ADDENDUM NO. 1

**2017 LDFA PAVING IMPROVEMENTS
CITY OF WIXOM
OAKLAND COUNTY, MICHIGAN**

March 2, 2017

2017 LDFA PAVING IMPROVEMENTS
ADDENDUM 1
SHEET 3 - WIXOM TECH/WEST TECH TYPICAL

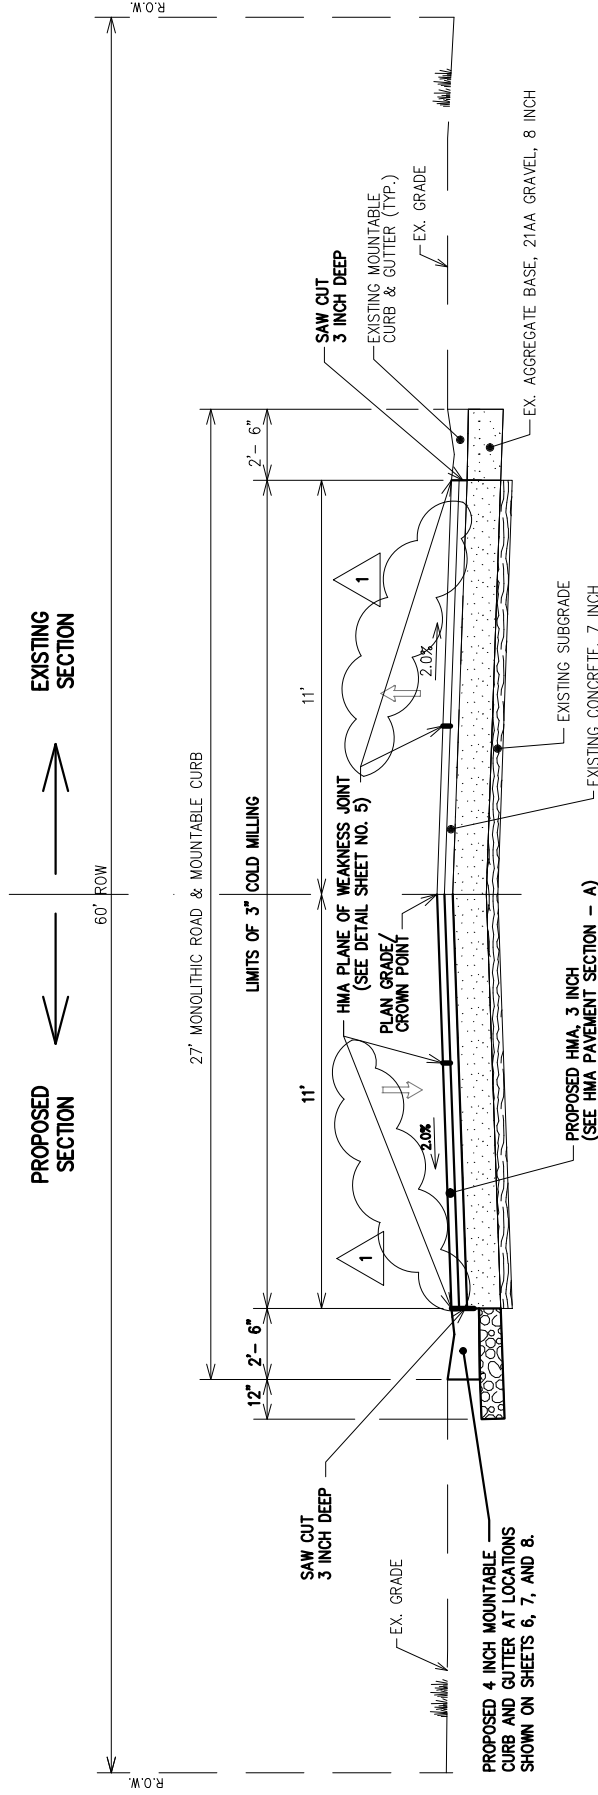
- 1. SHEET 3 – WIXOM TECH/WEST TECH TYPICAL - (Document Revised and Reissued).
 - a. Additional locations of HMA Plane of Weakness Joint now shown on typical section for Wixom Tech Drive and West Tech Drive.
- 2. SHEET 4 – BECK ROAD TYPICAL - (Document Revised and Reissued).
 - b. Additional locations of HMA Plane of Weakness Joint and Saw Cut, 4 inch now shown on typical section for Beck Road.

1 HMA PLANE OF WEAKNESS JOINT TO BE APPLIED ON PROPOSED HMA PAVEMENT ALONG CURB AND GUTTER EDGE OF METAL.
